Steven M. Clouse WRC Electrical System Improvements Phase 2B
Solicitation Number: CO-00547
Job No.: 21-6510

ADDENDUM 2
August 8, 2022

SHEET NO.
00E33
54 OF 227

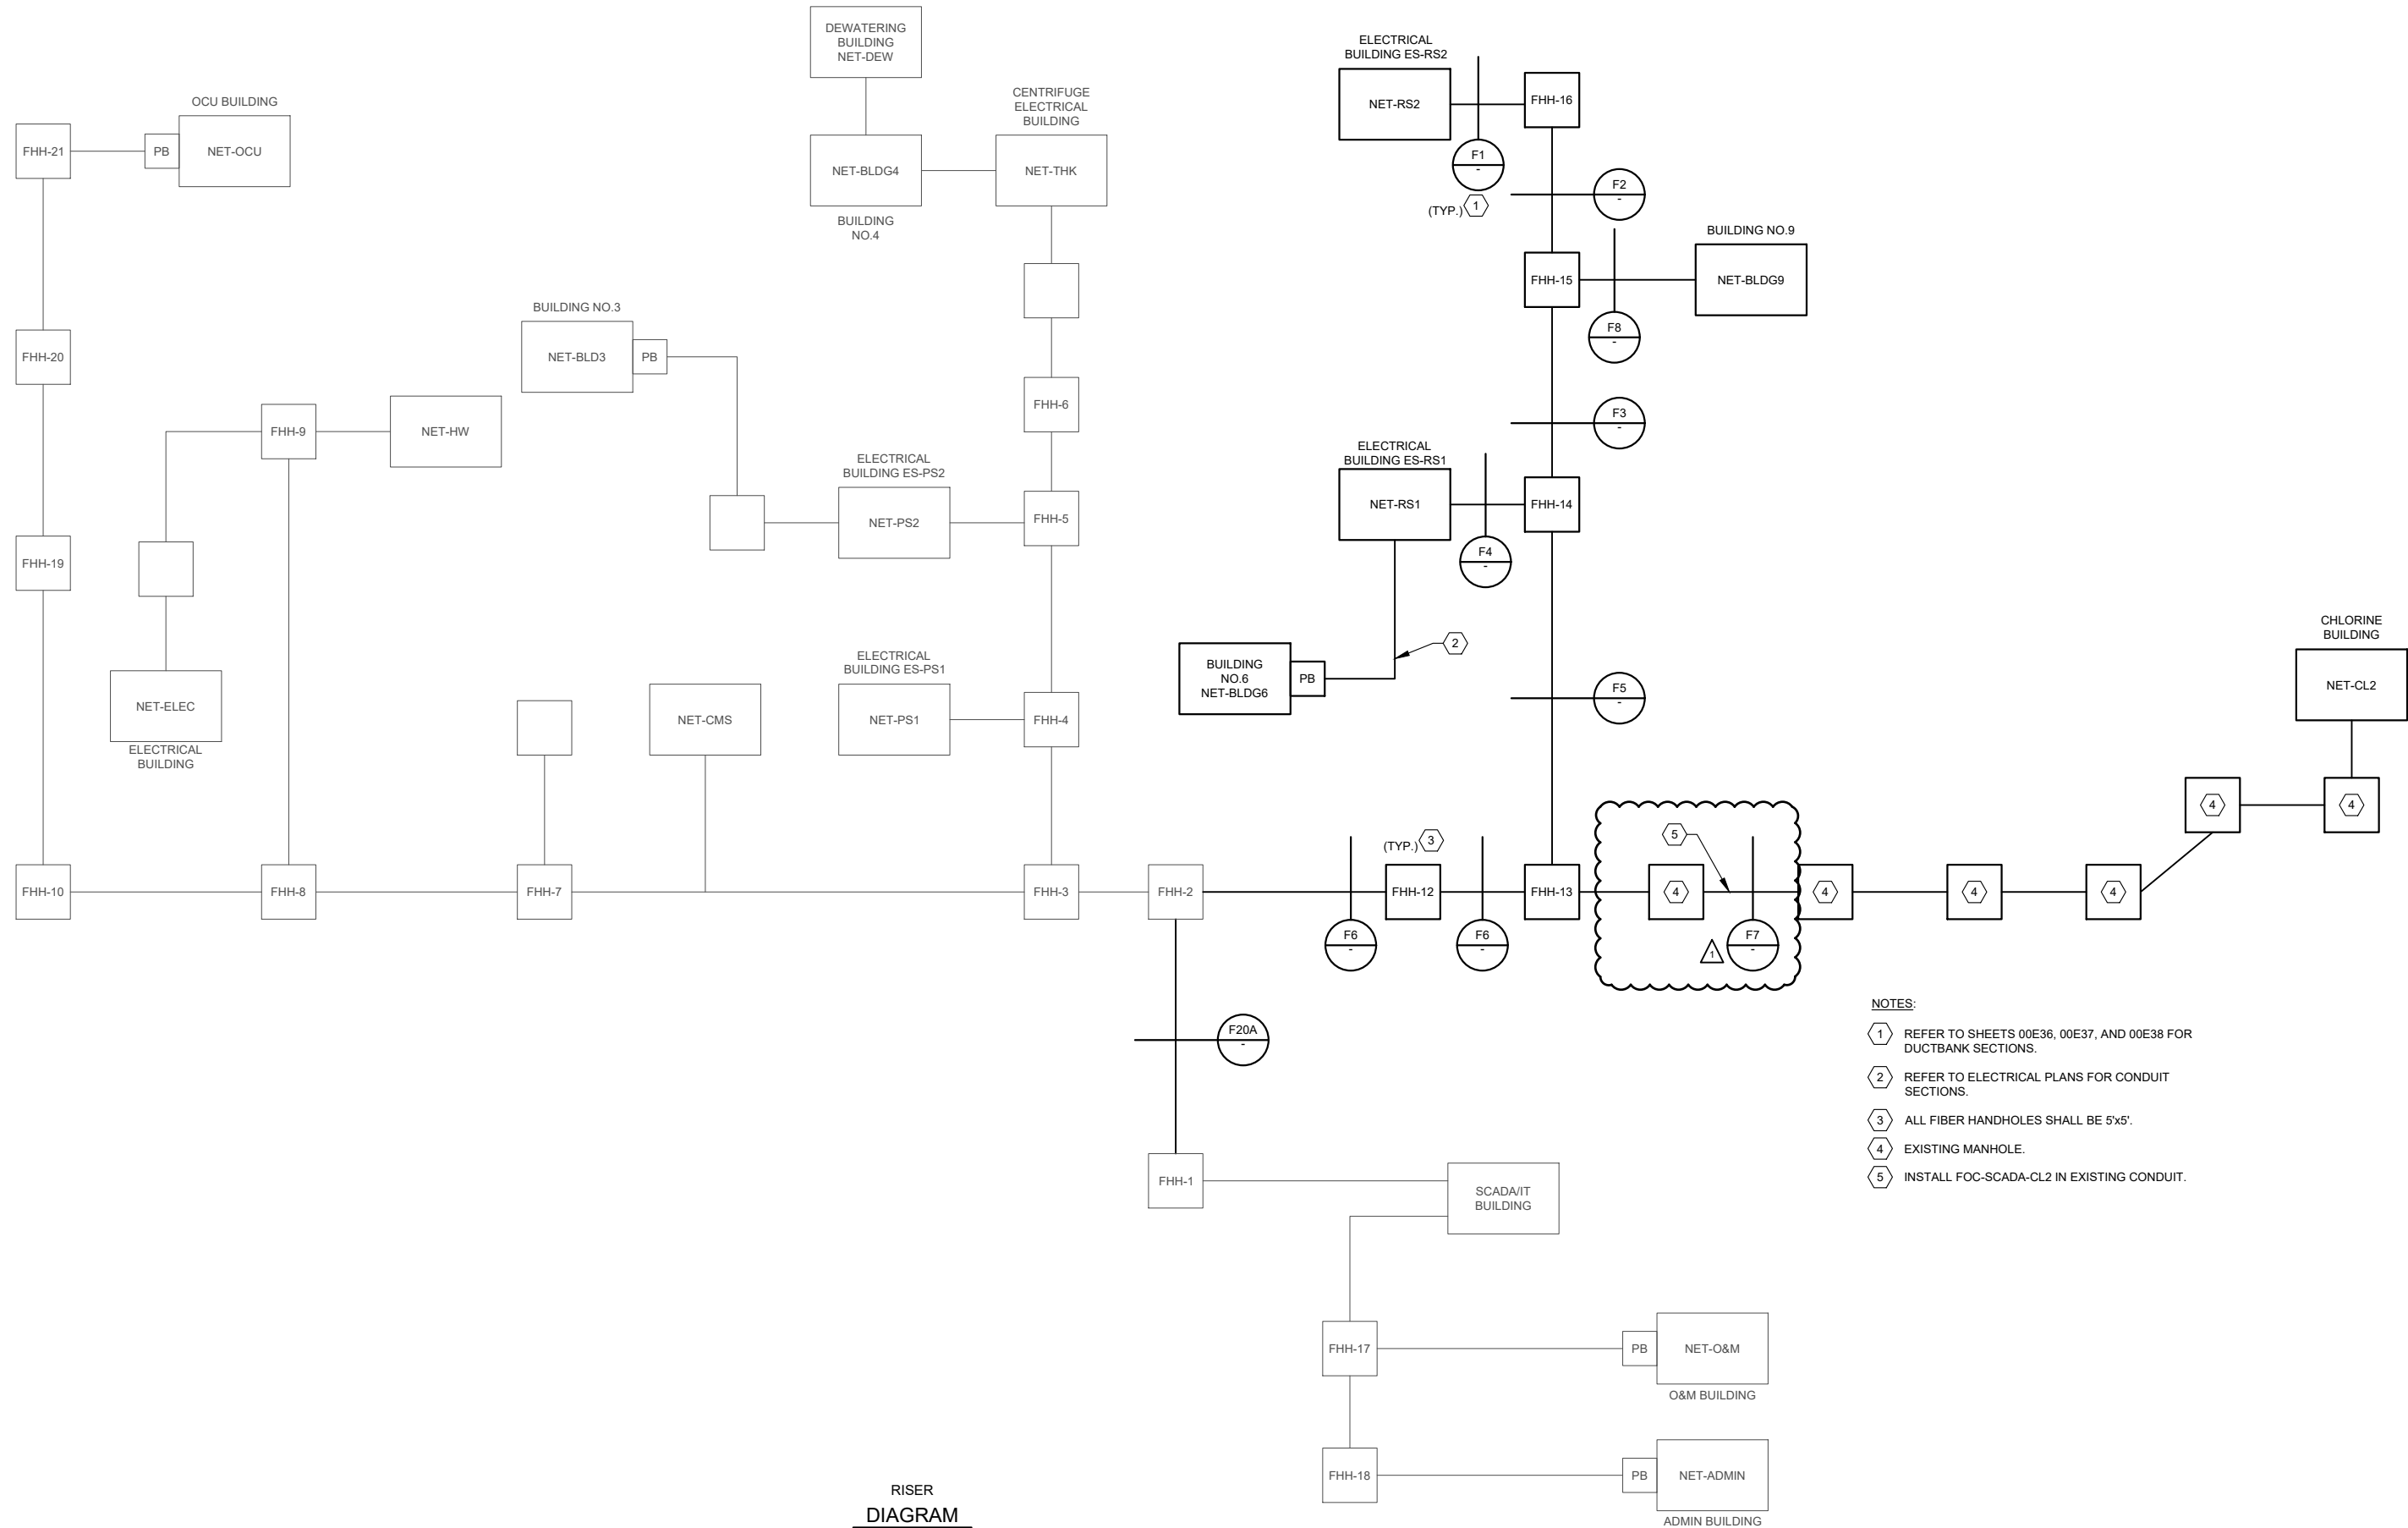
1. Remove the following sheets in their entirety and replace with the attached sheets:
 - a. 00E33
 - b. 00E35
 - c. 00E36
 - d. 00E37

1. Extended proposal opening date to September 7, 2022.
2. Additional opportunity was added for potential respondents to attend a site visit.
3. Updated Wage Decision
4. Clarified fiber network connections.
